From: Cornelis Duba [<mailto:Cornelis.Duba@endeavourenergy.com.au>]
Sent: Thursday, 9 August 2018 1:18 PM
To: DPE CSE Information Planning Mailbox
Cc: Simon Lawton ; Steven Baker
Subject: NSW Department of Planning and Environment Notice of Exhibition Tallawong Station Precinct South (SSD 9063)

I refer to the Department's letter of 10 July 2018 regarding Concept State Significant Development Application (SSD) for the Tallawong Station Precinct South, located at 69-79 Schofields Road, Rouse Hill in the Blacktown Local Government Area (Lots 13, 14 & 15 DP 1168129, Lot 10 DP 1185116) for a mixed-use precinct located south of the approved Tallawong Station comprising:

- Prudent Avoidance

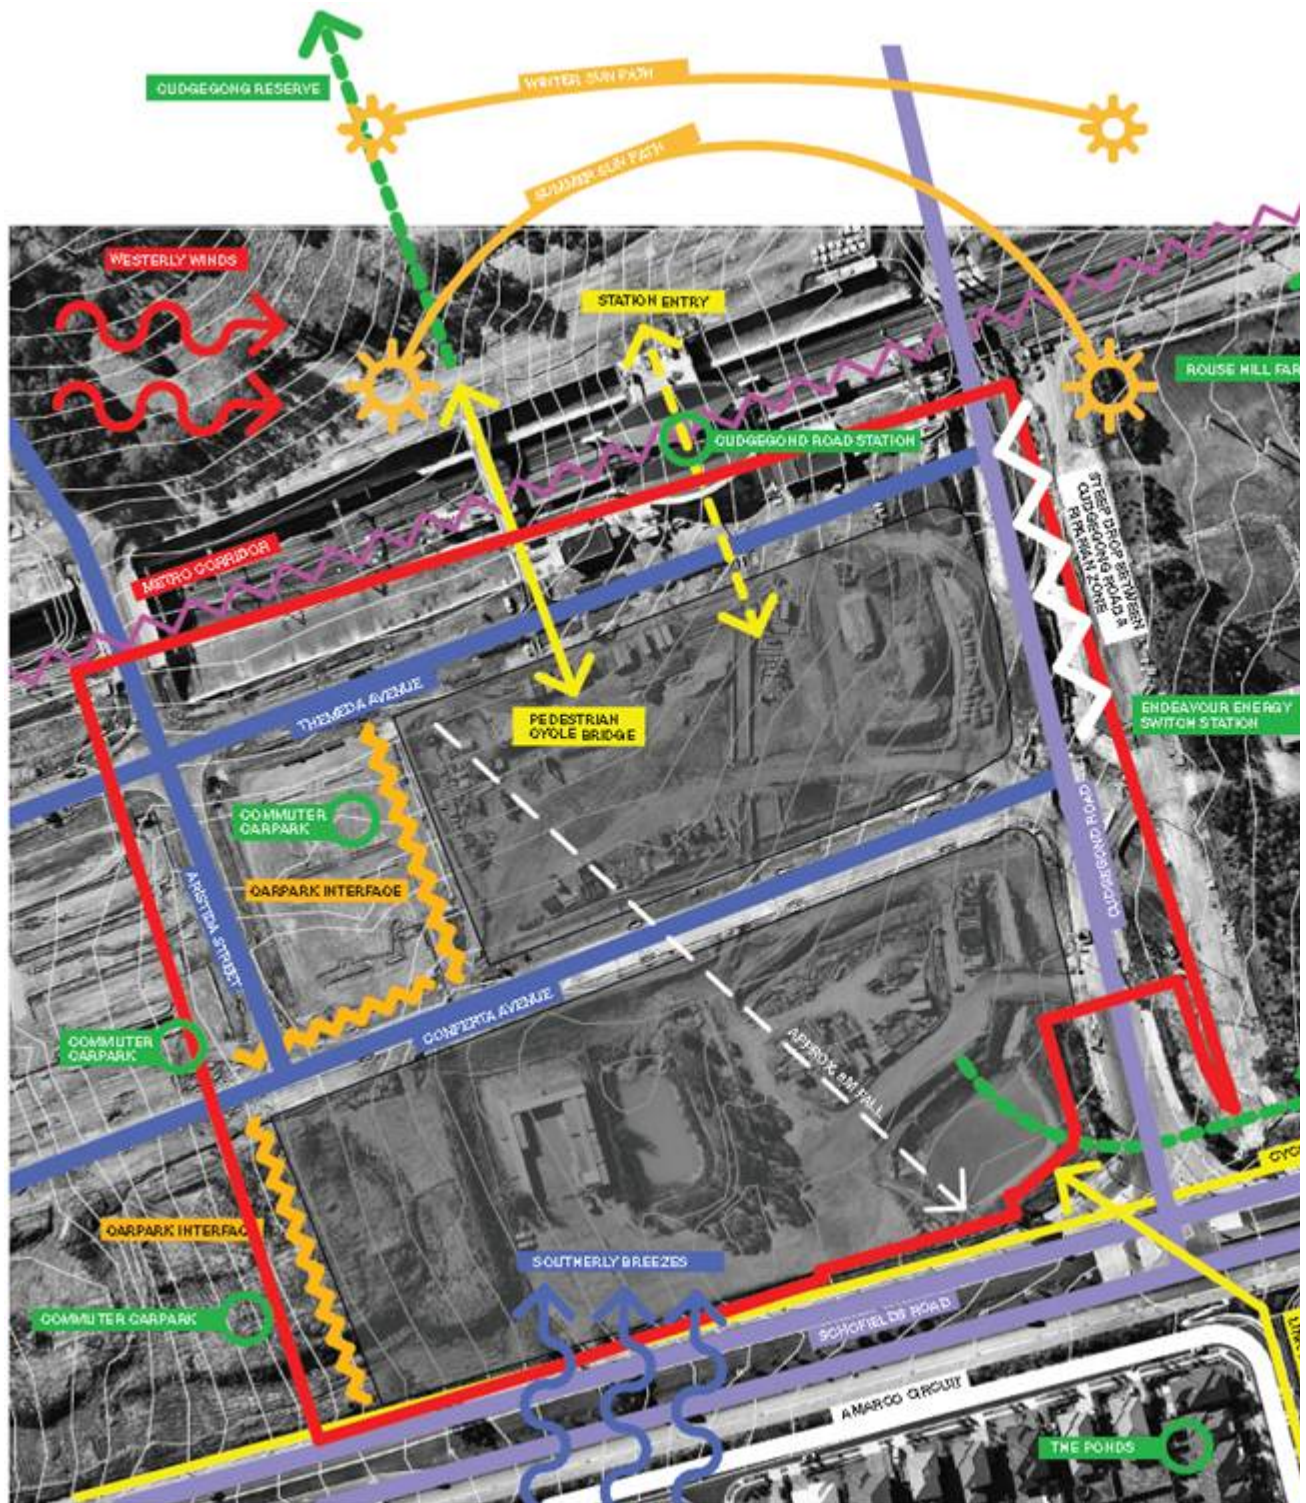
The electricity network is operational 24/7/365 ie. all day, every day of the year. The electricity industry has adopted a policy of prudent avoidance by doing what can be done without undue inconvenience and at modest expense to avert the possible risk to health from exposure to emissions from electricity infrastructure such as electric and magnetic fields (EMF) and noise which generally increase the higher the voltage ie. Endeavour Energy's network ranges from low voltage (normally not exceeding 1,000 volts) to high voltage (normally exceeding 1,000 volts but not exceeding 132,000 volts / 132 kV). In practical terms this means that when designing new transmission and distribution facilities, consideration is given to locating them where exposure to the more sensitive uses is reduced and increasing separation distances. These emissions are generally not an issue but with Council's permitting or encouraging development with higher density, reduced setbacks and increased building heights, new development can impact on existing electricity infrastructure. Where development is proposed in the vicinity of electricity infrastructure, Endeavour Energy is not responsible for any amelioration measures for such emissions that may impact on the nearby proposed development. Endeavour Energy believes that likewise Council should also adopt a policy of prudent avoidance by the siting of more sensitive uses away from any electricity infrastructure.

Typical magnetic field measurements associated with Endeavour Energy's activities and assets given the required easement widths, safety clearances etc. and having a maximum voltage of 132,000 volt / 132 kV, will with the observance of these separation distances not exceed the recommended magnetic field public exposure limits.

Endeavour Energy has noted that the Environmental Impact Statement does not appear to mention the proximity to Rouse Hill Switching Station or Feeder 9JA. The Urban Design Report as shown in the following extract of the Site Analysis Plan shows 'Endeavour Energy Switch Station' but there appears to be no detail / discussion about a 'complimentary interface' between the Rouse Hill Switching Station / Feeder 9JA and the buildings to the opposite side of Cudgegong Road.
